2.0

PROPOSED SCHEME CHANGES

2.5 THIRD FLOOR PLAN

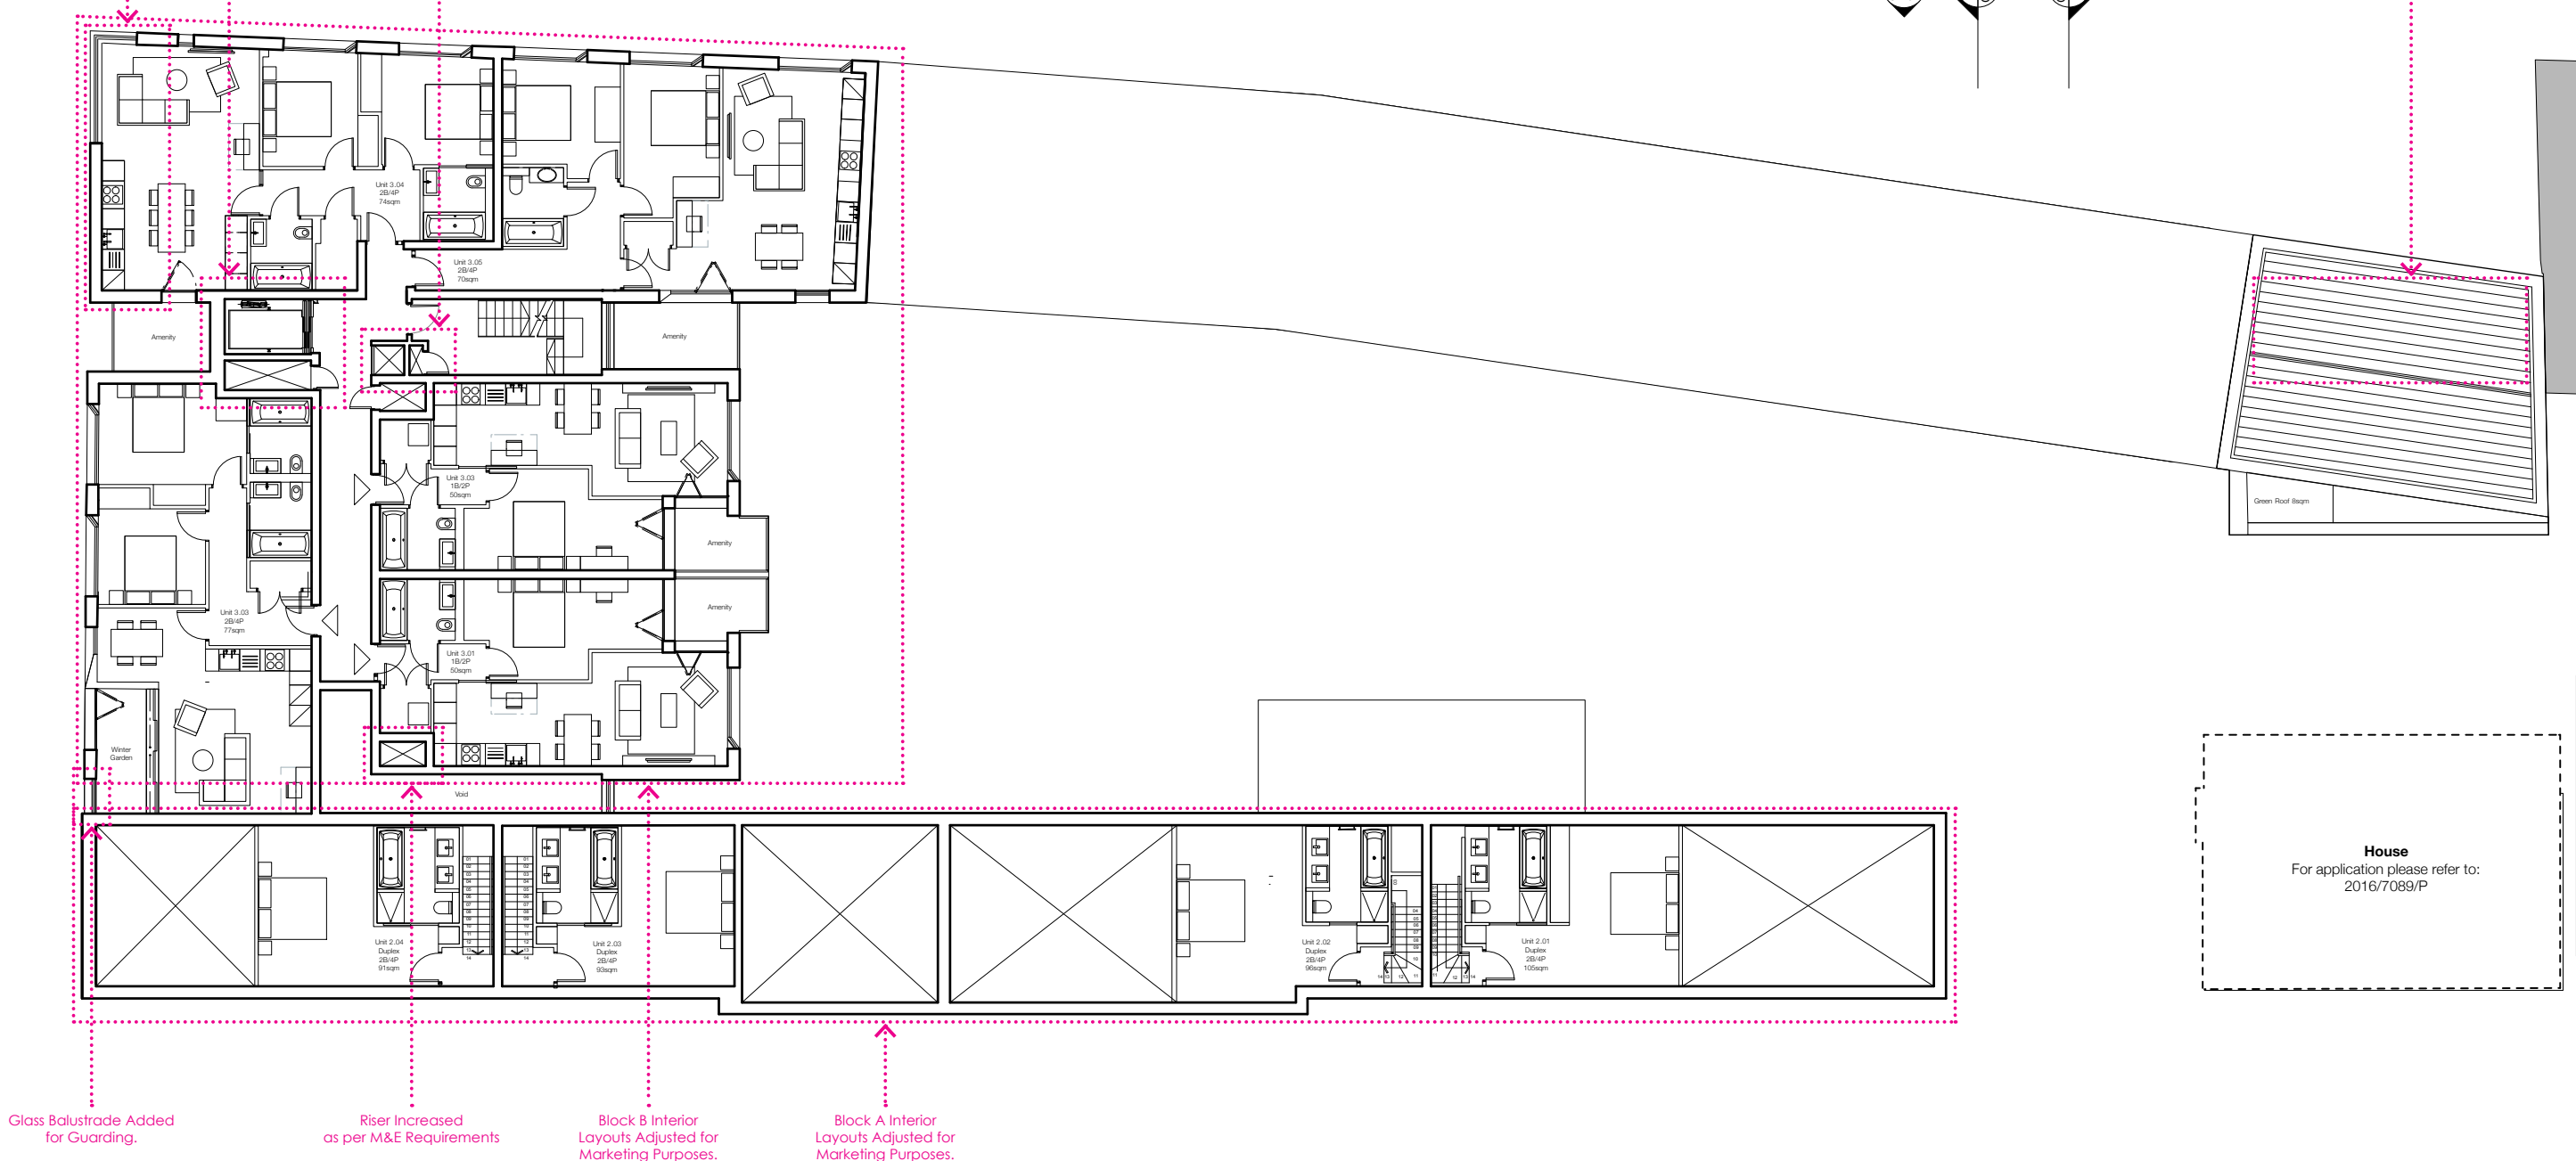
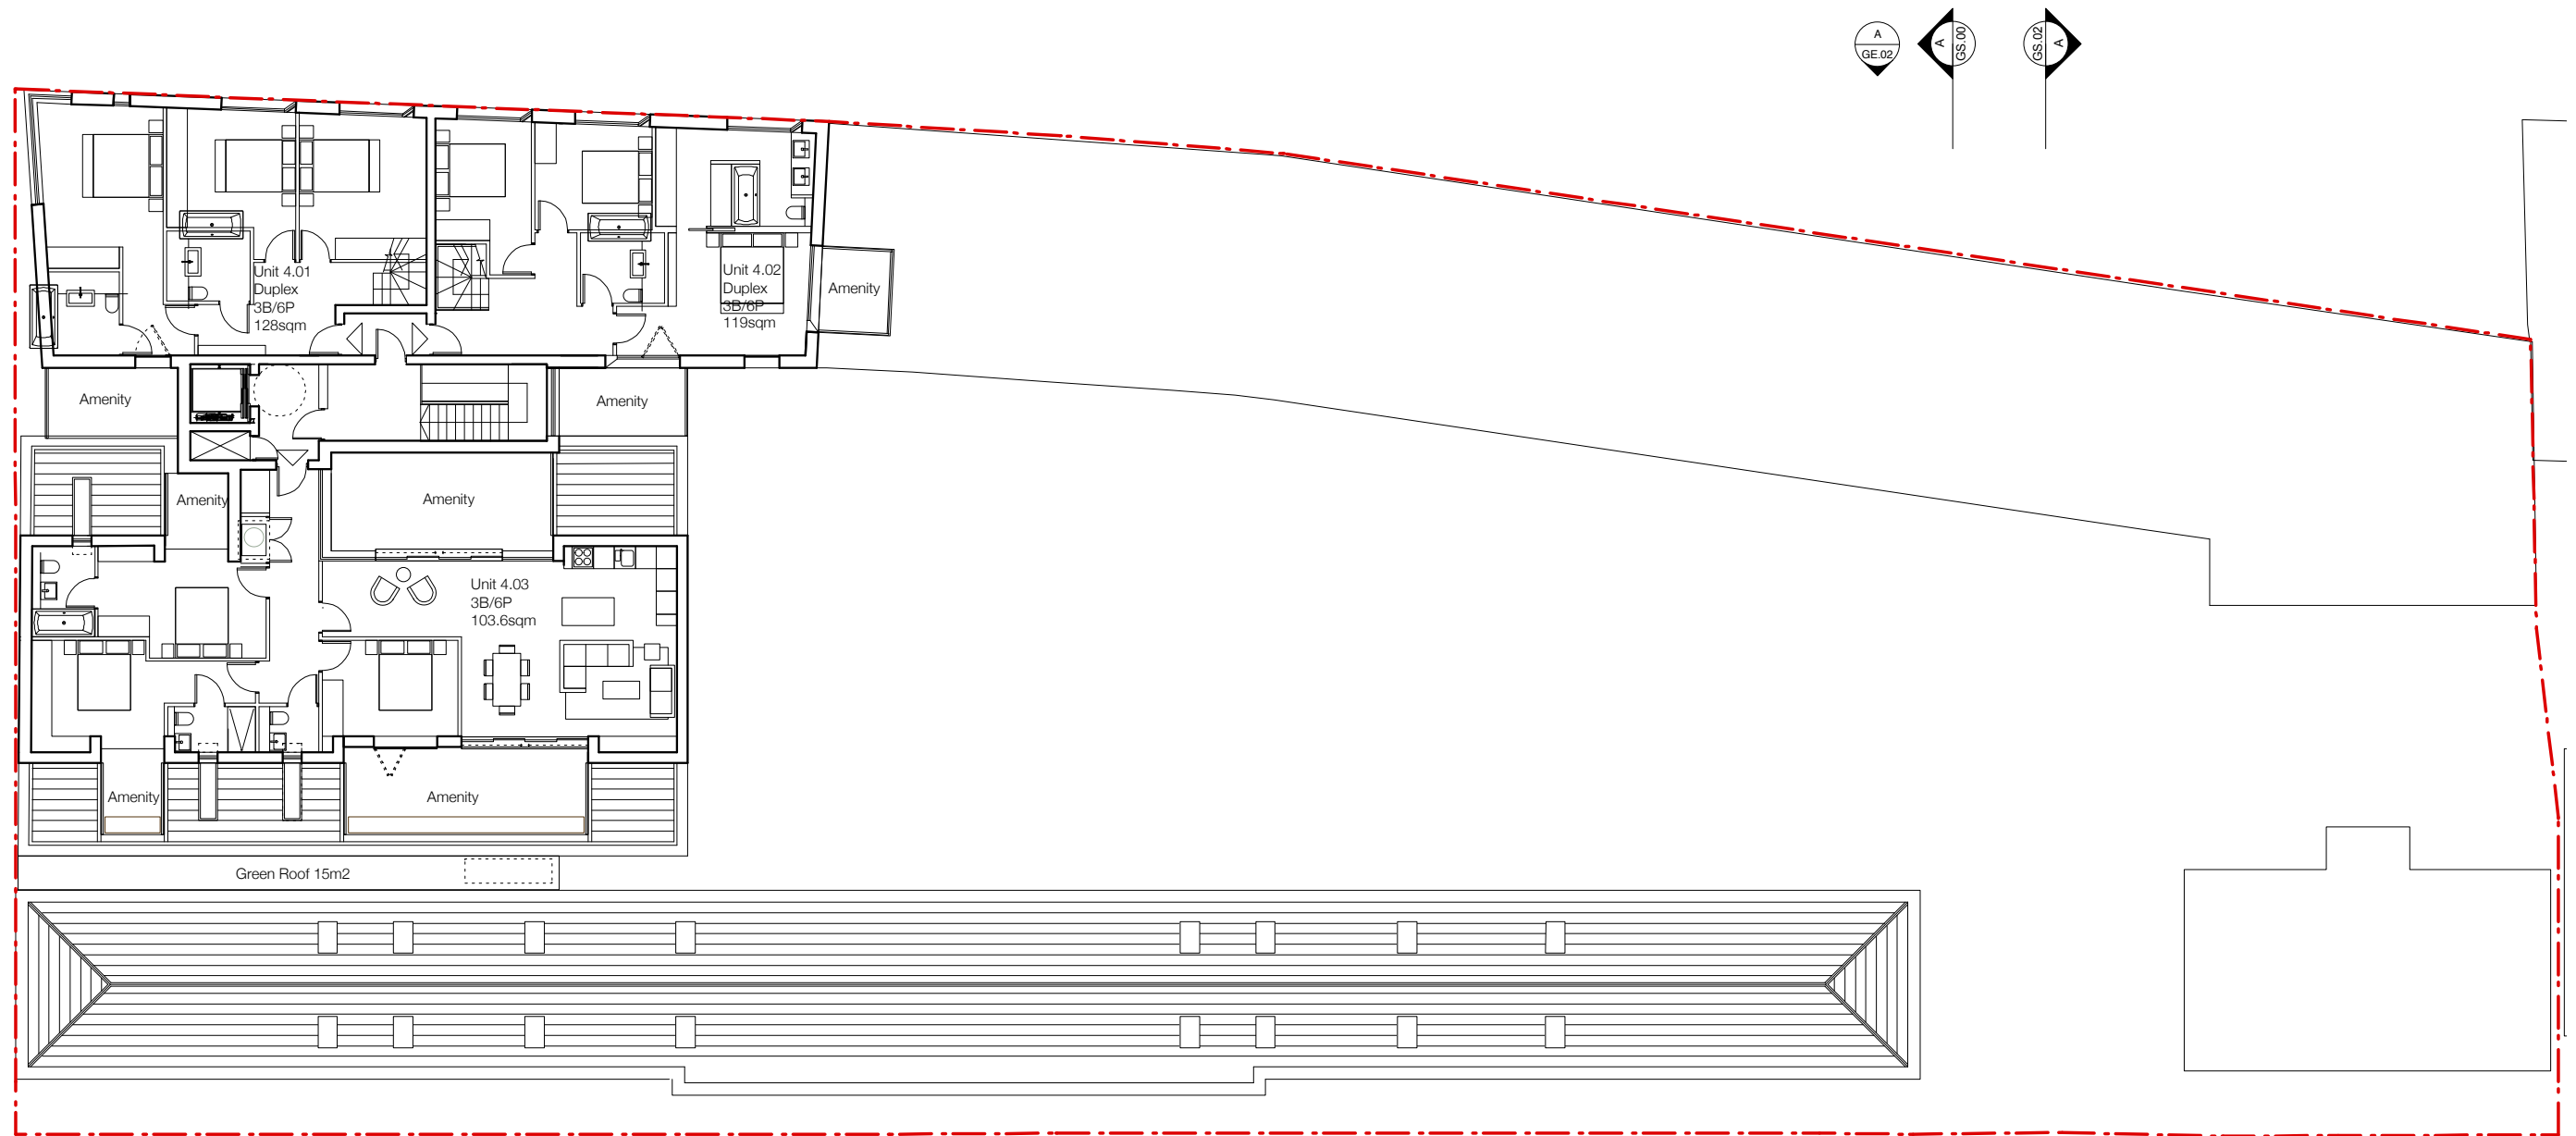
Building Facade Angle
Adjusted for Buildability whilst
Retaining the Architectural
Language.

Risers Enlarged as per Plant
Requirements

Risers Added as per Plant
Requirements

AOV Removed Following Review

2.6 FOURTH FLOOR PLAN

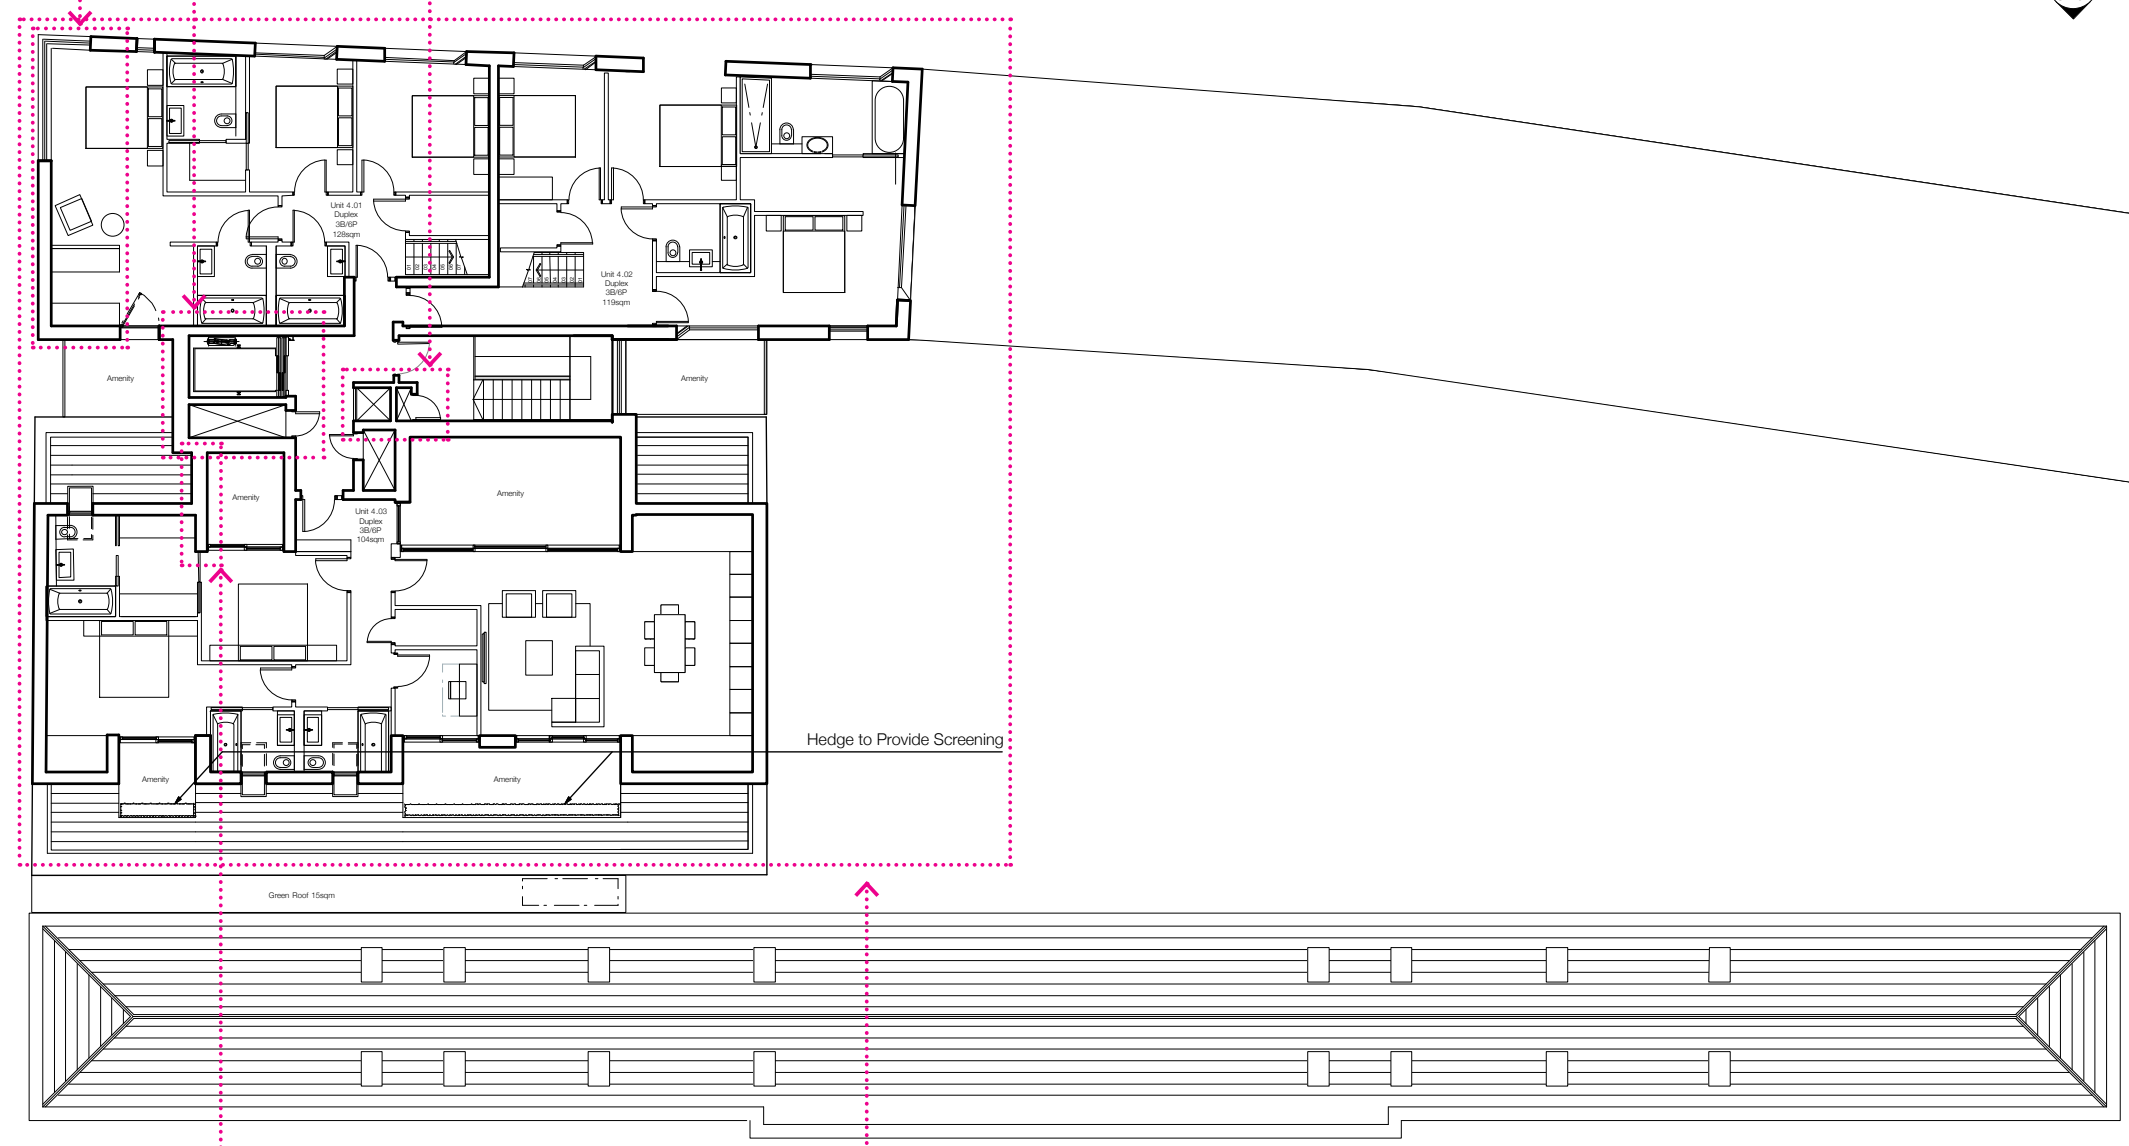
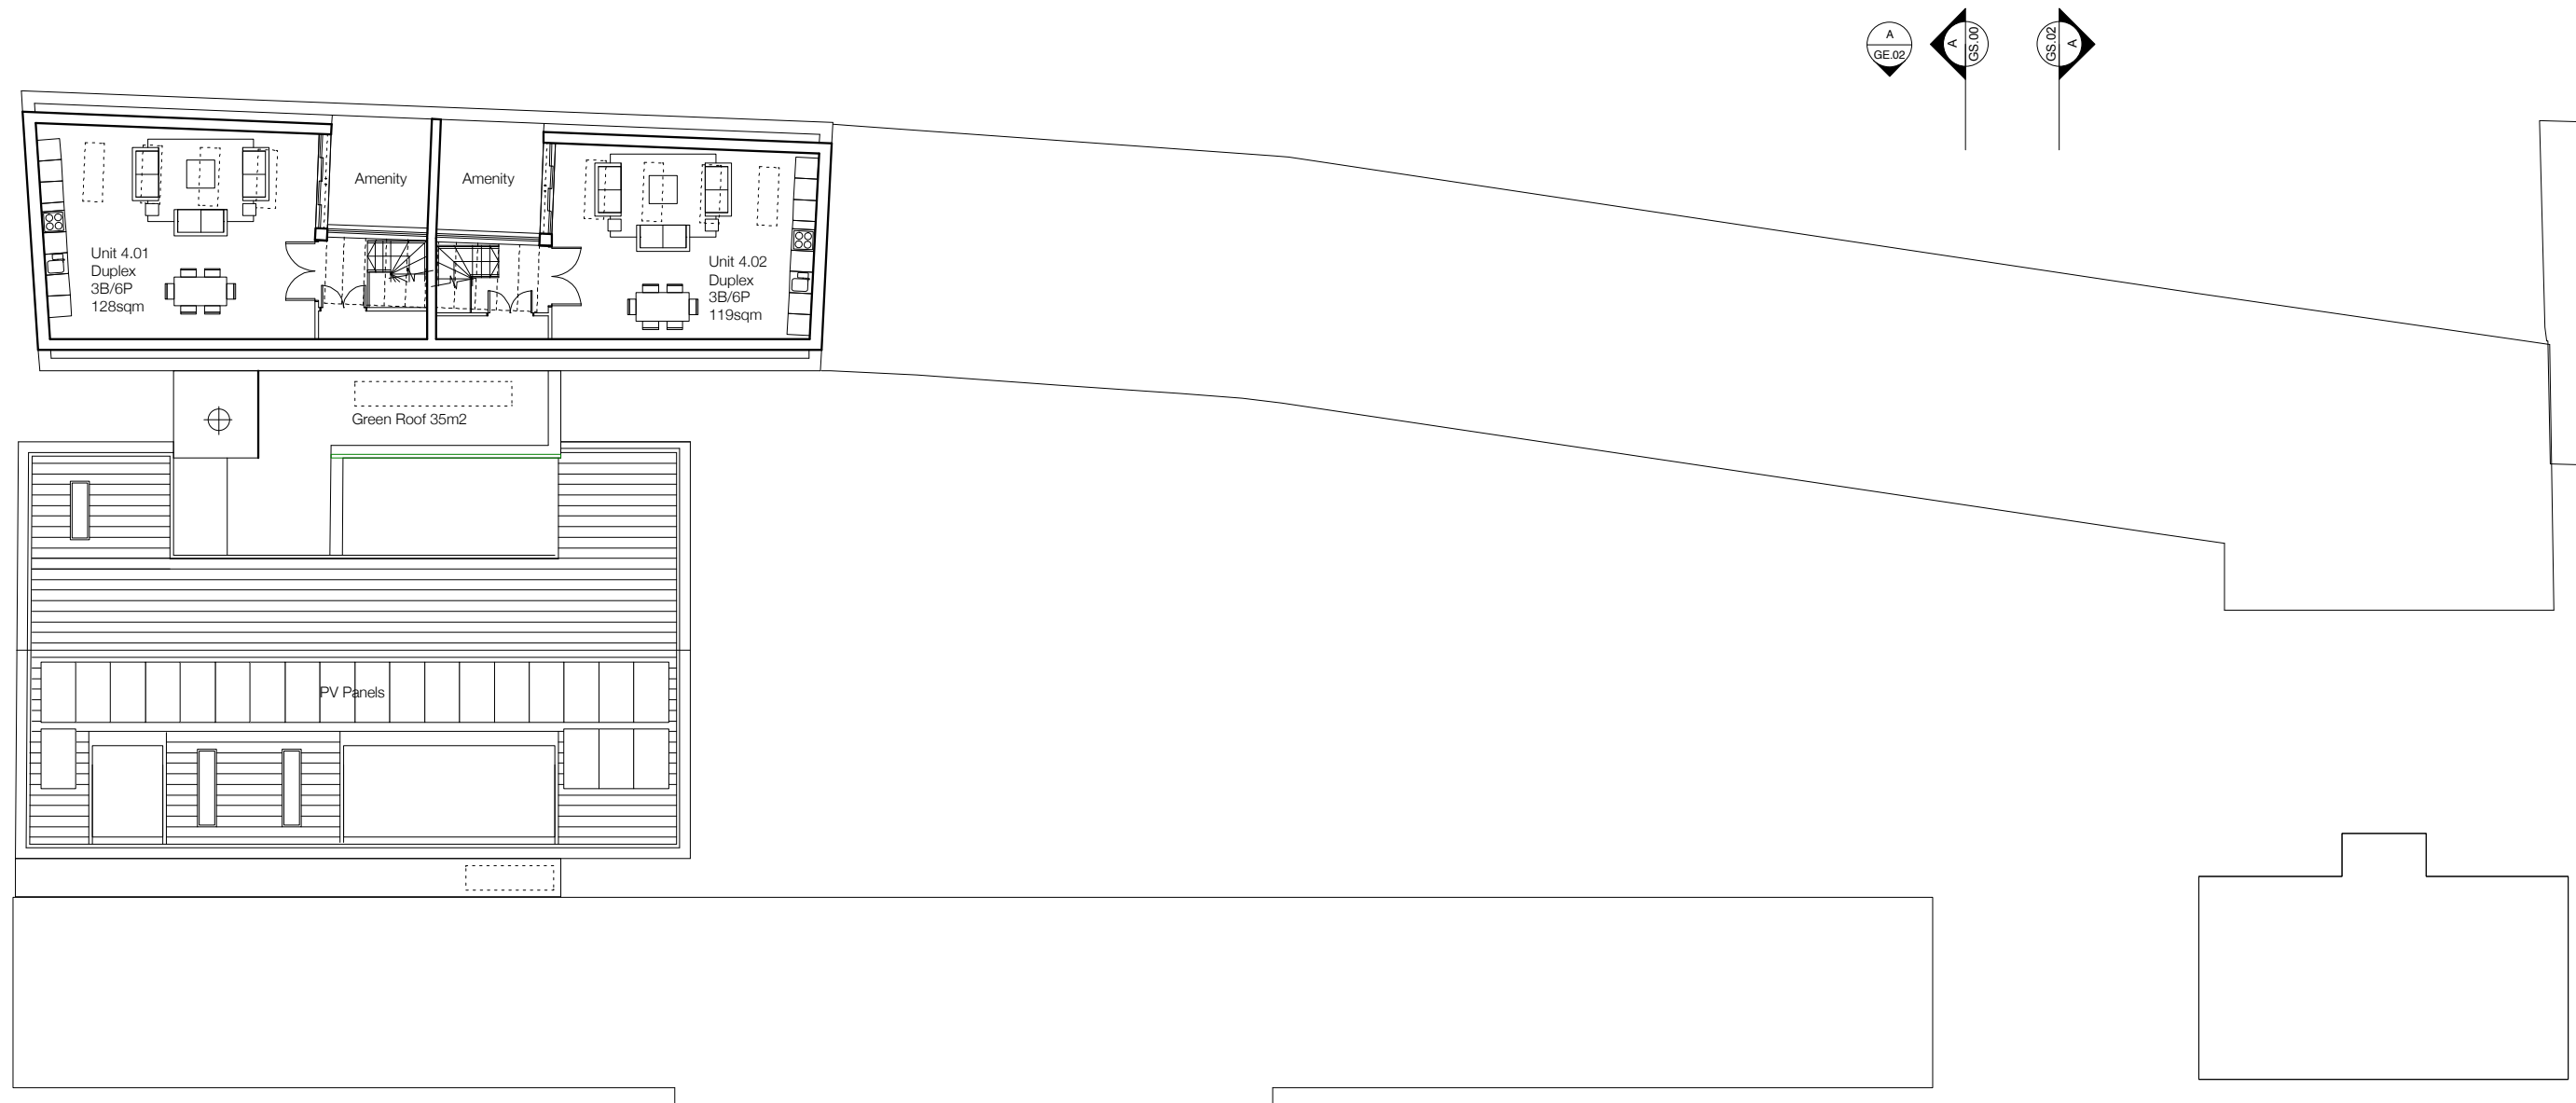
Building Facade Angle
Adjusted for Buildability whilst
Retaining the Architectural
Language.

Risers Enlarged as per Plant
Requirements

Risers Added as per
Plant Requirements

Hedge to Provide Screening

Green Roof 15sqm

Adjusted from Glazed to
Solid Wall Construction for
Buildability.

Block B Interior
Layouts Adjusted for
Marketing Purposes.
